Urgent Field Safety Notice

Manufacturer's reference: SB_RDC_2019_05

Important information on the Accu-Chek® Solo micropump system related to a new method to insert the pump into the pump holder in order to avoid insulin leakage

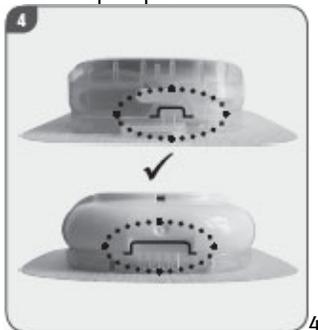
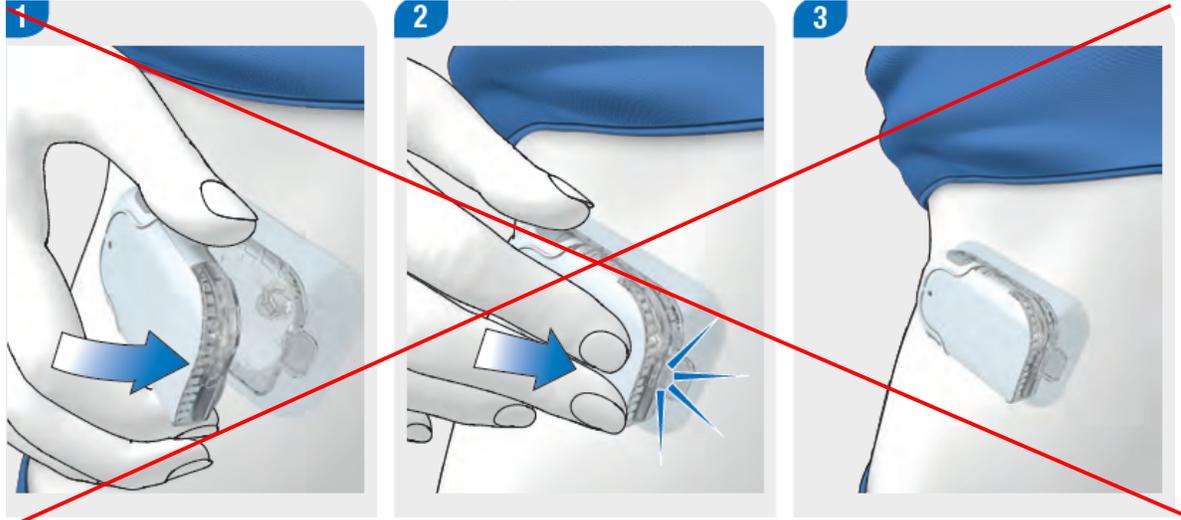
When the customer applies a side load on the Accu-Chek® Solo micropump when inserting the pump into the pump holder, insulin leakage at the septum of the cannula assembly could occur because of an improper penetration of the septum of the cannula assembly by the connecting needle. This may lead to high blood glucose values and potentially to severe hyperglycaemia up to diabetic ketoacidosis (DKA) with a serious outcome.

From now on, patients should only use the new **turn-in method** for inserting the Accu-Chek® Solo micropump into the pump holder following the procedure described below:

1 Place the reservoir needle on the grey cannula head of the pump holder.

2 Place the reservoir needle of the micropump on the grey cannula head of the pump holder.

3 Turn the micropump carefully into place. After a quarter turn, the micropump clicks into the front hooks on the pump holder.

4 Make sure the micropump engages properly with the front and back hooks on the pump holder. If not, press onto the pump shield until it clicks into the pump holder.

Patients should not use the insertion method (pictured below), which is currently described in the user's manual, any longer.
